General Manager,  
Pittwater Shire Council,  
Vuko Place,  
Warriewood. 2102

(Re:R0007/05 Proposed rezoning on non-urban land Sector 3  
Warriewood Valley)

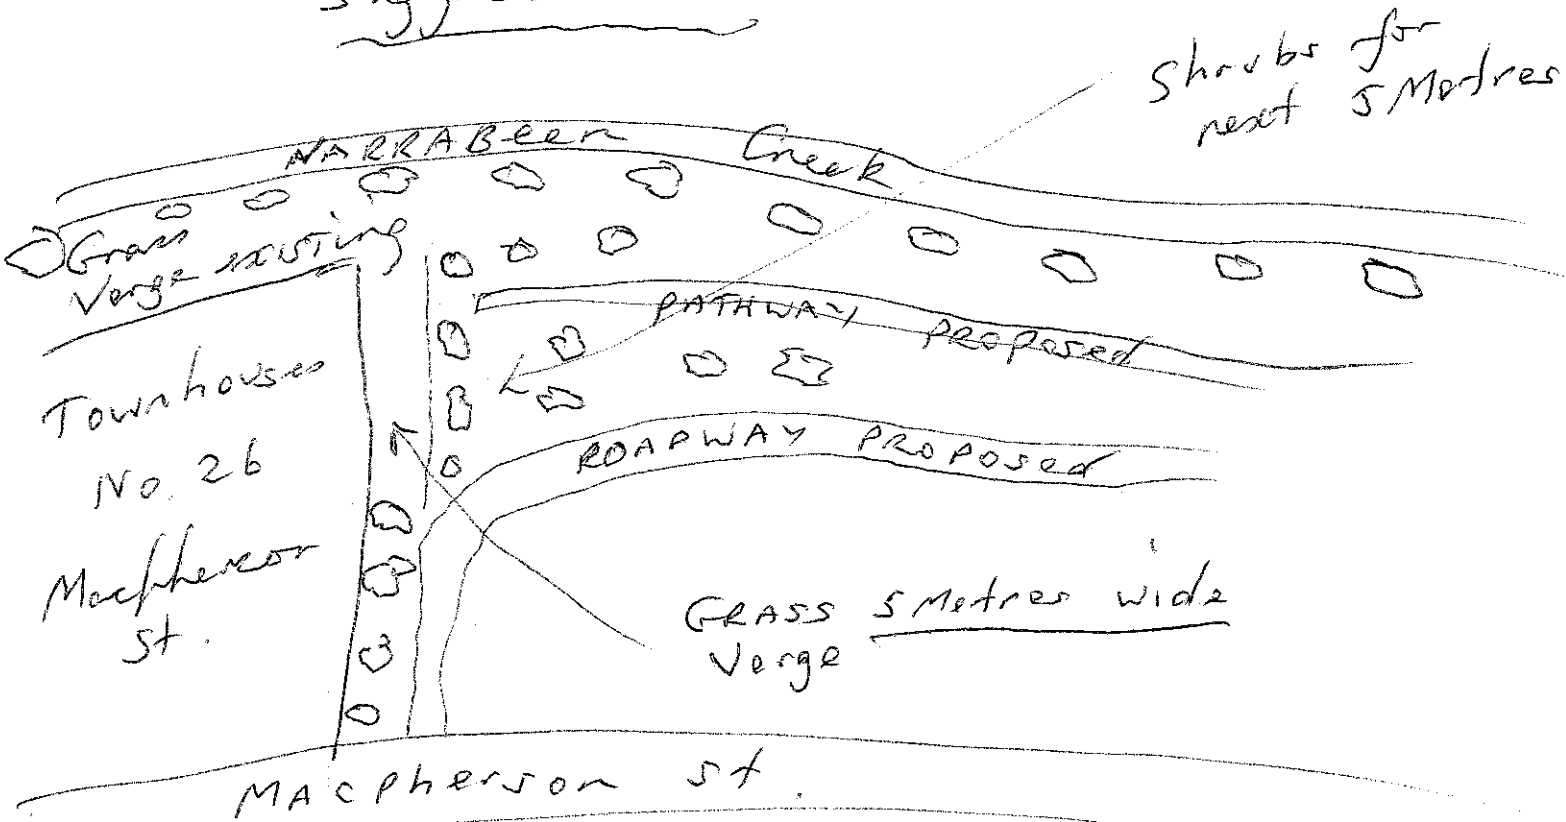
1/ The grassed area behind the townhouses is maintained and continued around the corner of the townhouses as a buffer and fire barrier, so that there is an area 5 metres wide of grass and then 5 metres of small native shrubs before the mixed plantings of gums and other natives.

2/ In order to maintain a fire break in the event of a future fire when the plantings have matured, I would suggest that against the side fence of No26 Macpherson Street as it approaches the creek that small shrubs such as

grevillea and bottlebrush are used to screen our side fence and the pedestrian path that you show terminating here is continued around so that it exists in the street parallel to the creek.

From the path, again small shrubs are planted so that this area does not become too dense with shrubs and at a distance of at least 10 metres from the fence you start your mixed tree plantings.

Suggestion 1

Suggestion 2
